## Determination 2016/049

# Regarding the refusal to issue code compliance certificates for an 18 to 20-year-old house with monolithic cladding at 53 Courage Road, Amberley

2.3.2 The resulting house is shown in the site plan sketch in Figure 1:

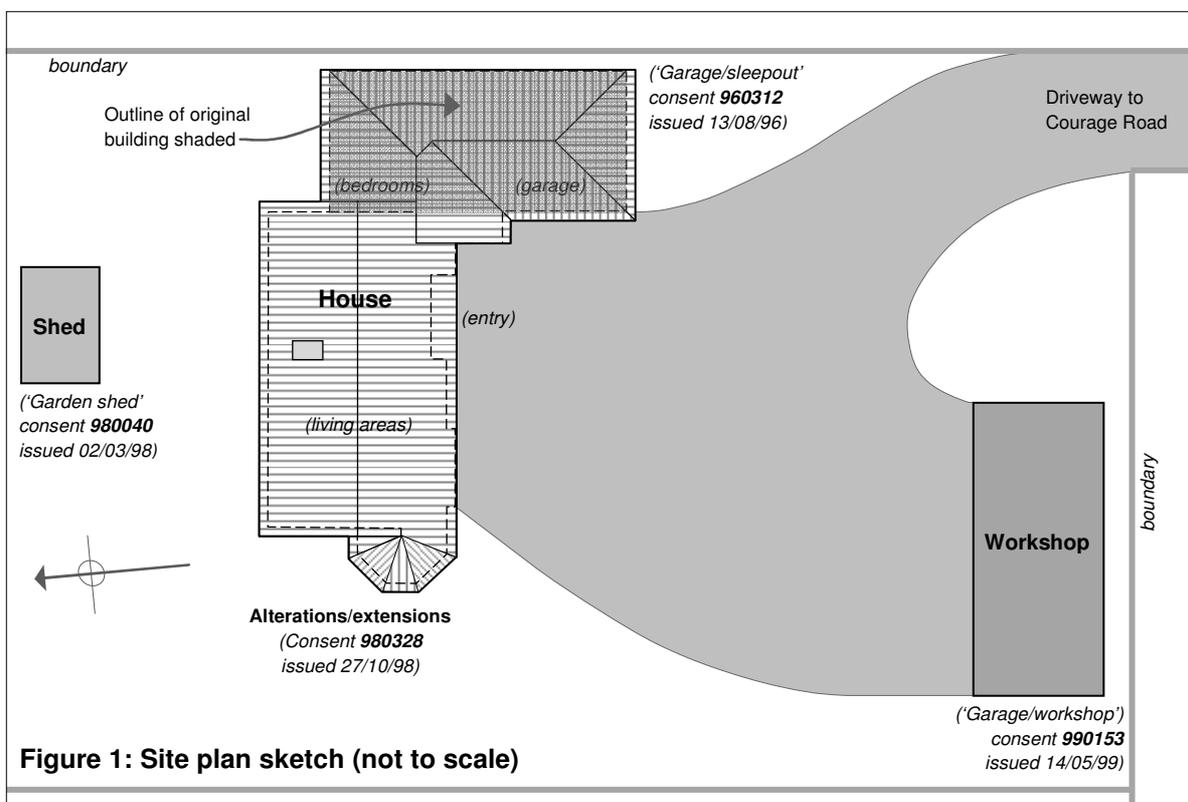
2.3.1 The original building was a proprietary garage/sleepout with a simple rectangular plan and gable roof. The 1998 extensions more than doubled the floor area and included:

- removal of a veranda that had been added to the west of the original building in 1997
- addition of a new wing to the west, providing living, dining and kitchen areas
- alterations of the original building to provide 4 bedrooms and 2 bathrooms
- new roof framing, roofing and cladding to most walls of the original building.
